Access Compliance Report

Public Rights-of-Way

Intersection ID: 14201	Main Street: RANLO_AV	Cross Street: BALDWIN_AV	Location: W
ADA ID: 904A1BD3EAEF	Ramp Type: BlendTrans1	Initial Pass/Fail: Pass	Overall Compliance: No
		Severity Score: 2.75	
Codes/Mitigation Info/Possible Solution		Field Measurements/Component Compliance

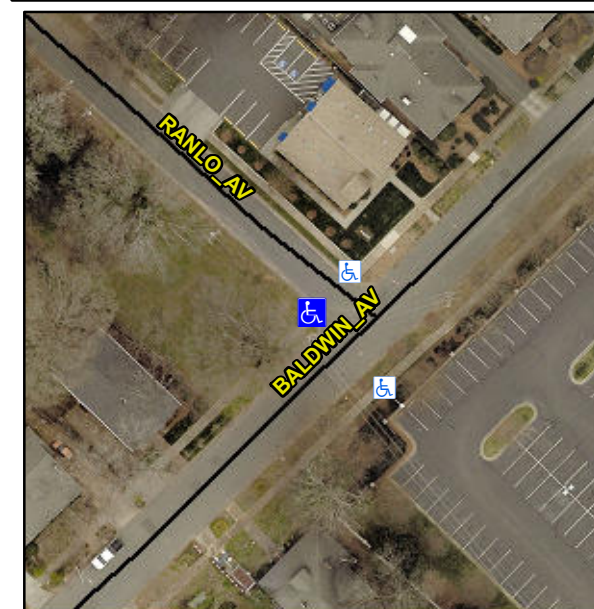
R304.5.3, R305.1.4, R305.2

Compliance	Description	Data	Compliance	Description	Data
N/A	Ramp Length (in)	66.0	Yes	BlendTrans Slope (%)	4.1
Yes	Ramp Width (in)	57.0	No	BlendTrans XSlope (%)	3.3
N/A	Flare Type LT	Sloped	N/A	Flare Type RT	Sloped
N/A	Flare Slope LT (%)	0.6	N/A	Flare Slope RT (%)	4.3
N/A	Flare Traversable LT?	No	N/A	Flare Traversable RT?	No
Yes	Landing Length (in)	60.0	Yes	DWS Provided?	Yes
Yes	Landing Width (in)	59.0	Yes	DWS Contrast?	Yes
Yes	Landing Slope (%)	1.8	Yes	DWS Length (in)	26.0
Yes	Landing X Slope (%)	1.3	No	DWS Full Width?	No
N/A	Landing Curb? (Y/N)	No	No	DWS Offset (in)	3.0
N/A	Shared Landing?	No			
Yes	Gutter Ponding?	No	Yes	Gutter Slope (%)	3.4
Yes	Gutter Lip Ht (in)	0.0	No	Gutter X Slope (%)	3.6
N/A	Painted X Walk1?	No	N/A	Painted X Walk2?	No
	X Walk 1 Direction	To SE		X Walk 2 Direction	To NE
	X Walk 1 Width (in)	N/A		X Walk 2 Width (in)	N/A
	X Walk 1 Slope (%)	2.6		X Walk 2 Slope (%)	4.0
	X Walk 1 X Slope (%)	1.6		X Walk 2 X Slope (%)	2.1

Remove & Replace Curb Ramp With Two New Directional Ramps or Equivalent. Remove & Replace Gutter.
